SUBJECT: RESPONSE TO NMED LETTER OF NOVEMBER 1, 1994, REGARDING TECHNICAL AREA (TA)-50 RADIOACTIVE LIQUID WASTE TREATMENT PLANT

GROUND WATER DISCHARGE PLAN APPLICATION

TA-50 RLW Treatment Facility Ground Water Discharge Plan

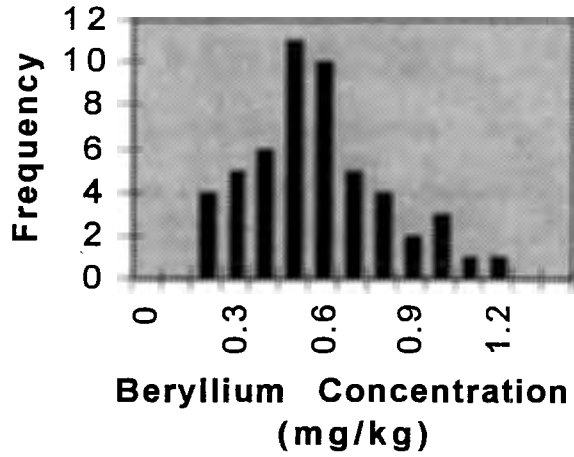
NMED Issue

4. LANL shall summarize all deviations from the approved Workplan.

Stainless steel coring tool for collection of undisturbed samples. All soils around TA-50 are disturbed. Numerous activities have caused disturbance, and mixing of surface soils after potential airborne deposition would have occurred. Therefore, the stainless steel scoop method, collecting soil to a depth of 6 inches, was the more appropriate method to collect any potentially contaminated soils than use of the stainless steel coring tool.

Field laboratory for analysis of samples. The field laboratory originally proposed in the Work Plan was not used. Instead, all samples were submitted to a fixed-site laboratory. The envisioned field laboratory was not practical. Fixed-site laboratory methods are generally more reliable for large suites of analytes.

Additional samples collected at Ten Site Canyon. Field screening identified a localized area of elevated gross alpha/beta at a "hummock," a physical feature consisting of a small deposit of sediment in the stream channel. It was decided that the single sample originally planned for that area was not sufficient to characterize the hummock. Additional samples were collected upstream and downstream from the hummock.
